ADDENDUM #4

North Carolina Aquariums
Jennette's Pier Decking Repair and Replacement
SCO ID# 22-25352-01A

Addendum #04
North Carolina Aquariums
Jennette's Pier
Decking Repair / Replacement
Nags head, North Carolina

- Item 4 Drawings – Sheet A3.0** has been revised and reissued (see **Attachment #2**).
- #1/A3.0 Typical Pier Section: Detail tags have been updated to reference details on sheet A3.2. Size of continuous FRP support has been changed from 3x3 to 3-1/2"x3.

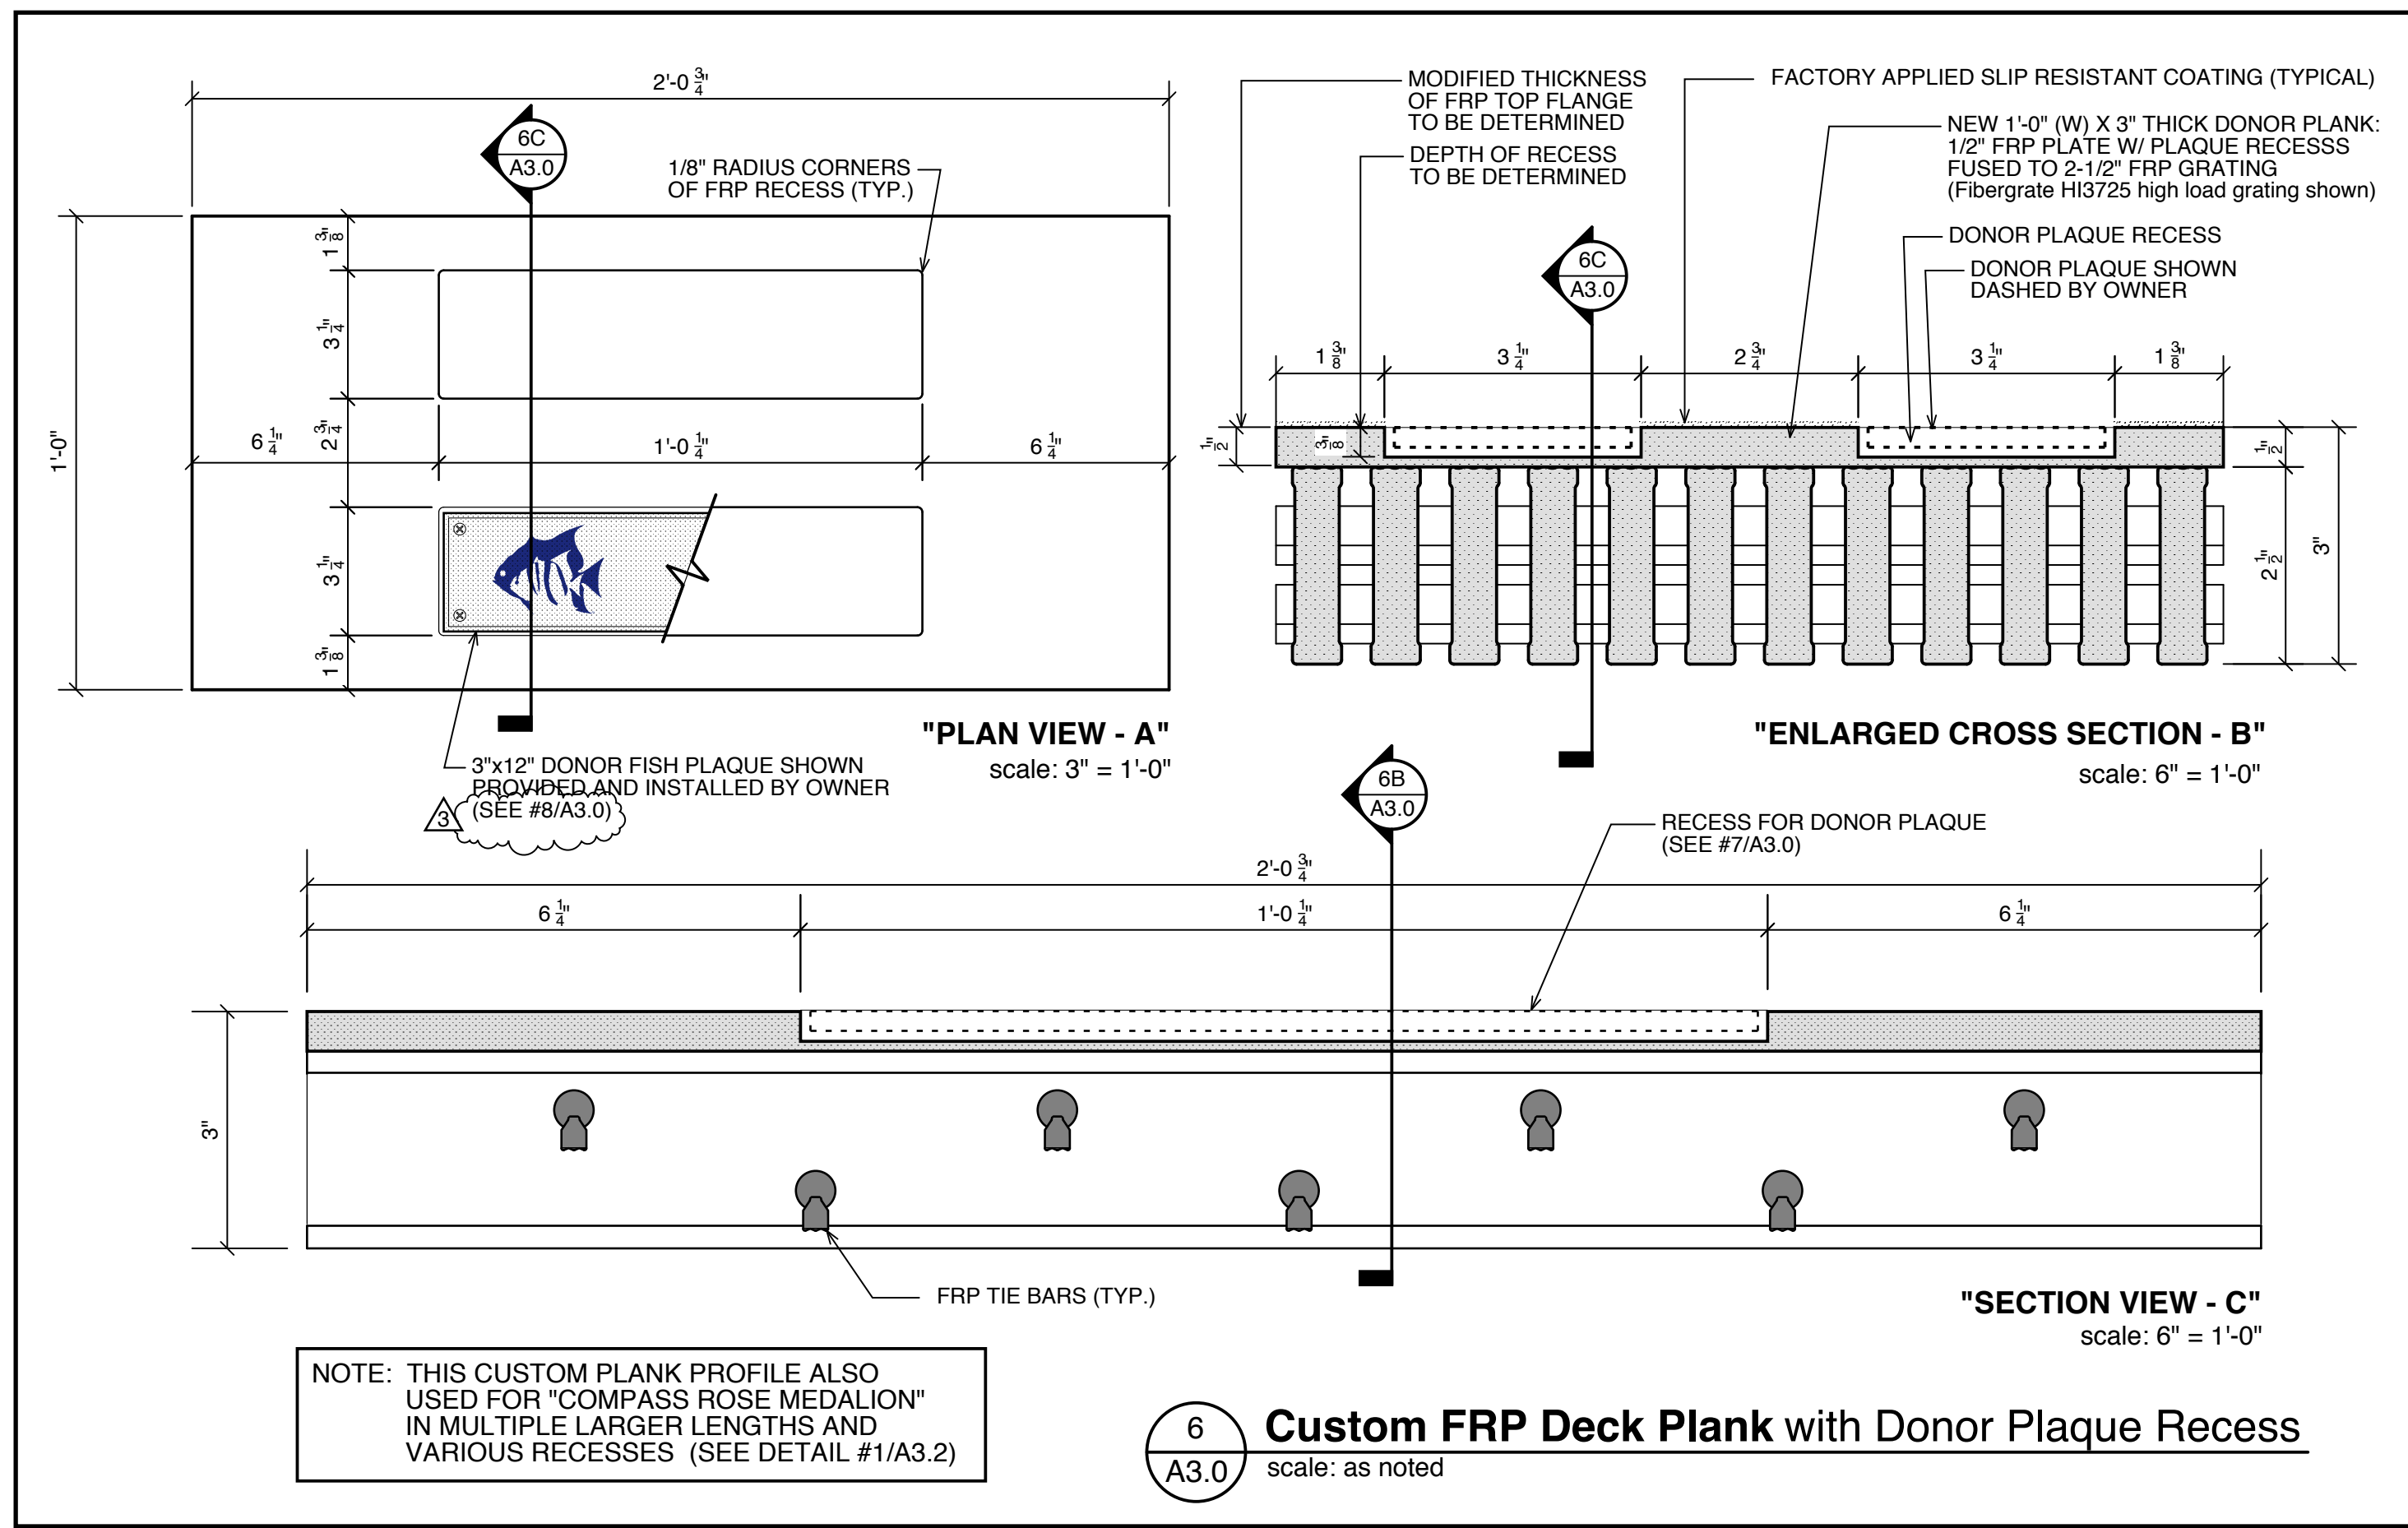
- Item 2** **Drawings – Sheet A2.0** been revised and reissued (see **Attachment #1**).
- a. #1/A2.0 Enlarged Plan now shows 1-1/2" FRP grating at Beach Access stairs #1 & #2. Additional notes have been added at these stairs.

- b. #1/A2.0 Enlarged Plan; notes regarding 2-1/2"x12" FRP planks at start of ramp has been changed to 3"x12" FRP planks.
 - c. #1/A2.0 Enlarged Plan; Location of delineation line between wood framing and concrete has been moved to correct location.

- d. Plan #2/A2.0 Enlarged Bath House Decking; Decking material has changed to 1-1/2" FRP grating. FRP decking shall be used on deck, stairs and ramps. (stairs not hatched for clarity.)

- e. #3/A2.0 Step Detail; Treads and Risers have been changed to 1-1/2" FRP grating. In addition, P.T. wood framing shall be provided on stairs and landing to raise FRP grating to meet top of new FRP decking.

- f. Decking LEGEND has been revised to include the 1-1/2" FRP grating.
- Item 3** **Drawings – Sheet A2.1 and A2.2:** Triangular deck areas supported by wood framing as noted will receive same 3"x12" FRP deck planks as provided in surrounding areas. Disregard notes and legends indicating the use of 2-1/2"x12" FRP planks in these areas. The top of existing wood joists and timber support framing shall be trimmed in place approximately 1/2" to align with top of new FRP ledgers.

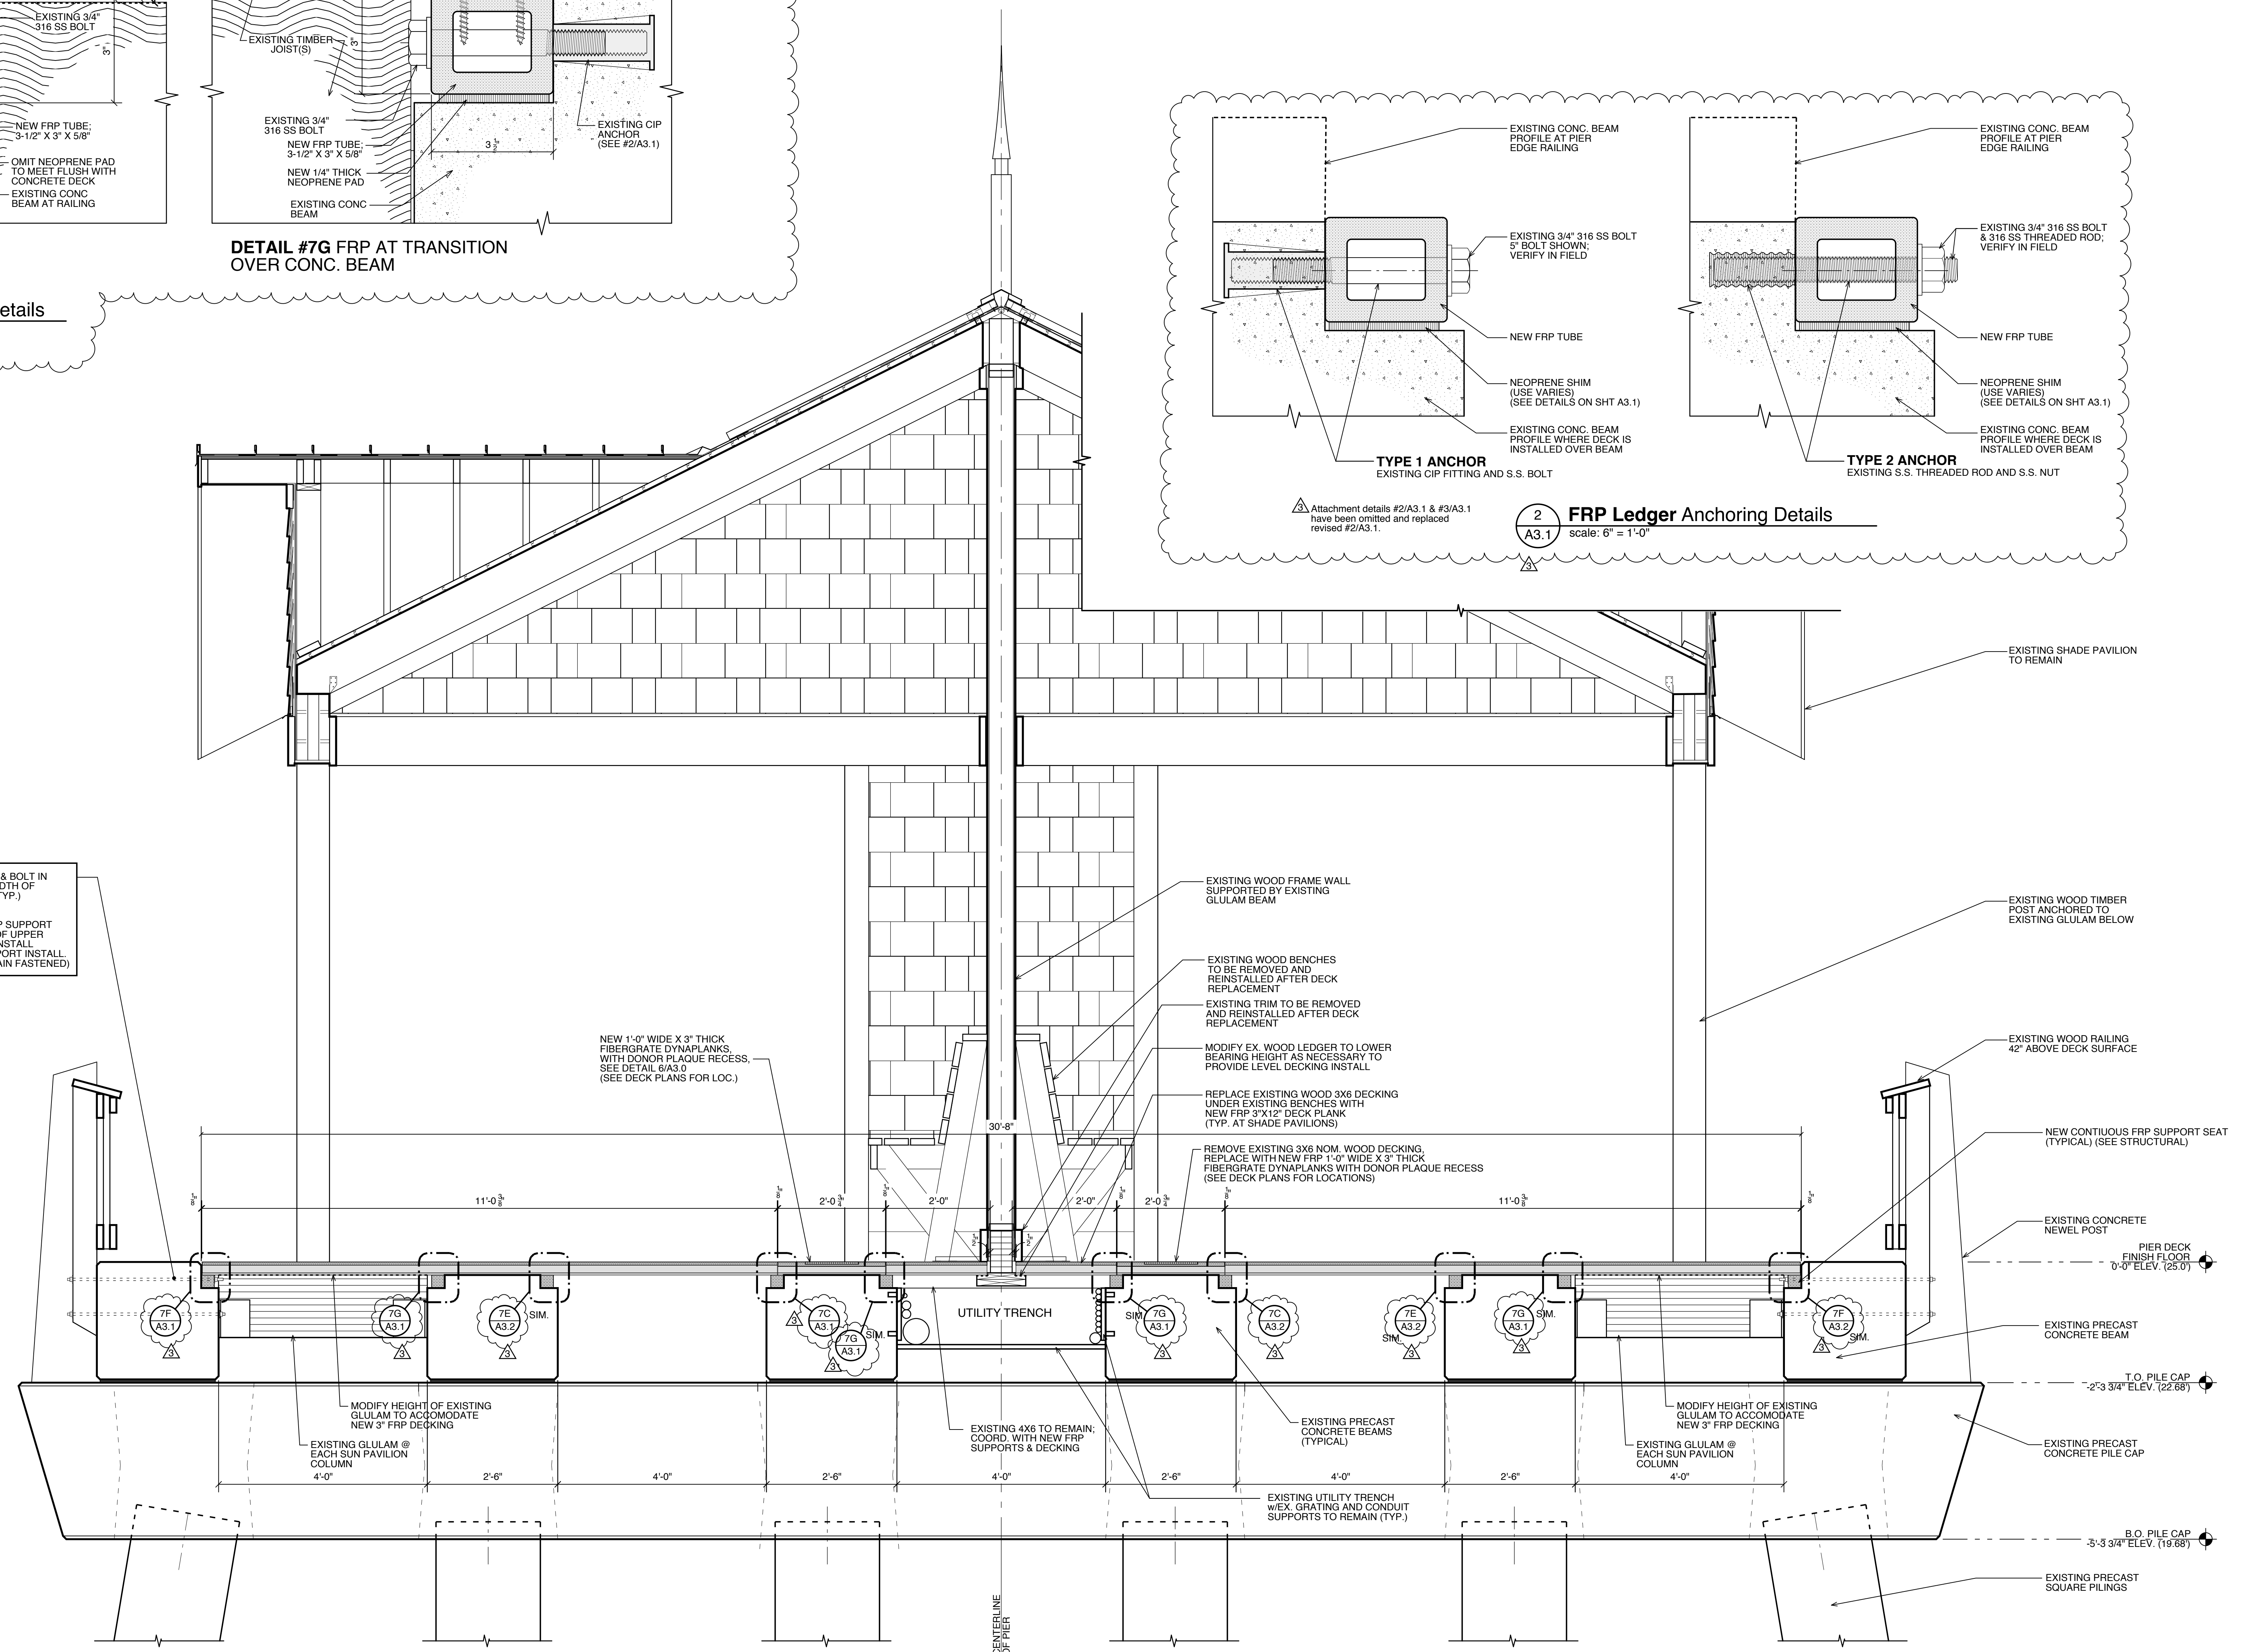
EXISTING THREADED ROD & BOLT IN PVC SLEEVE THROUGH WIDTH OF CONC. BEAM TO REMAIN (TYP.) (TYPICAL EACH POST)

FOR INSTALLATION OF FRP SUPPORT REMOVE NUT & WASHER OF UPPER POST ANCHOR ONLY. REINSTALL IMMEDIATELY AFTER SUPPORT INSTALL (LOWER ANCHOR TO REMAIN FASTENED)

BULLETIN/SHEET #:	BD-005
SHEET REF.:	N/A
DATE:	11.21.24
CHECKED BY:	GCW
DRAWN BY:	AJT

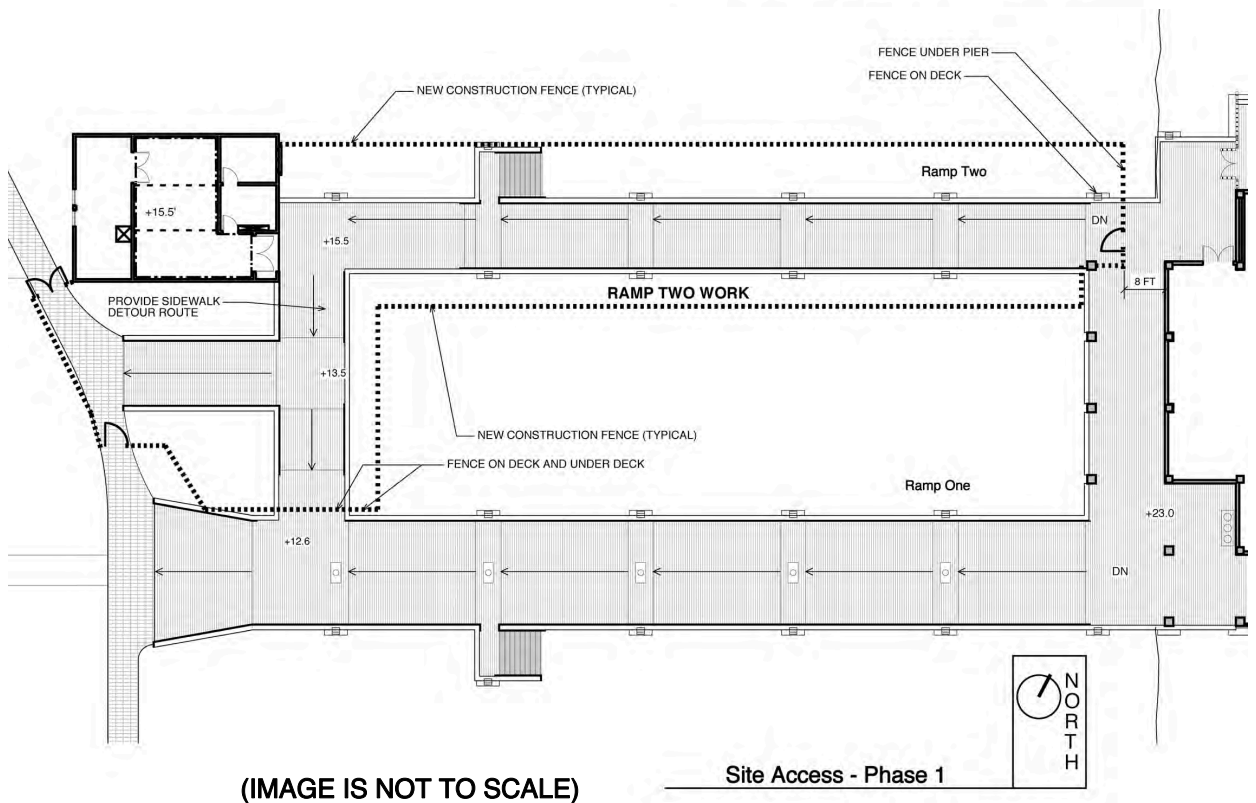
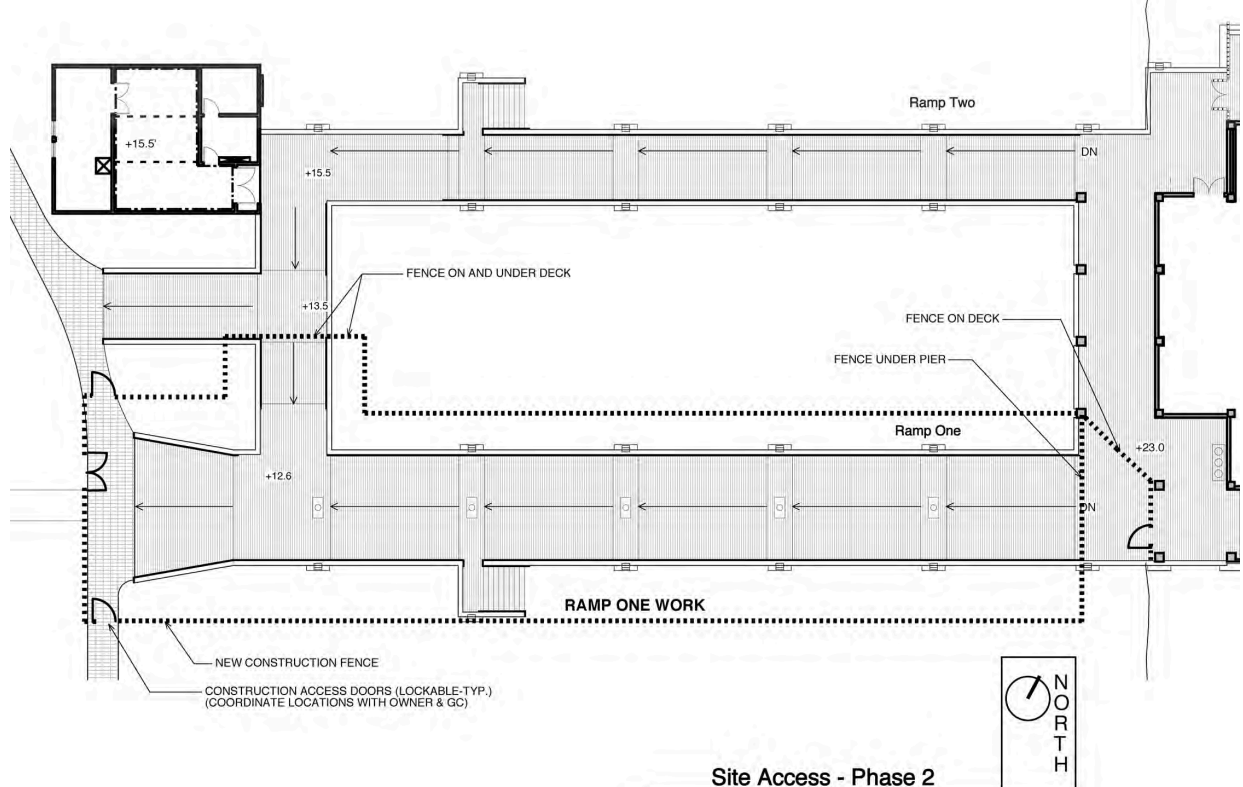
- Item 9 General Items**
- Construction phasing required to provide continuous egress to Pier House; one ramp to remain open while the other is being renovated. Provide temporary barricade/fencing and gates as necessary to prevent entry into the area of work. Coordinate final locations with owner. See Bulletin Drawing #B005. (See **Attachment #5**)
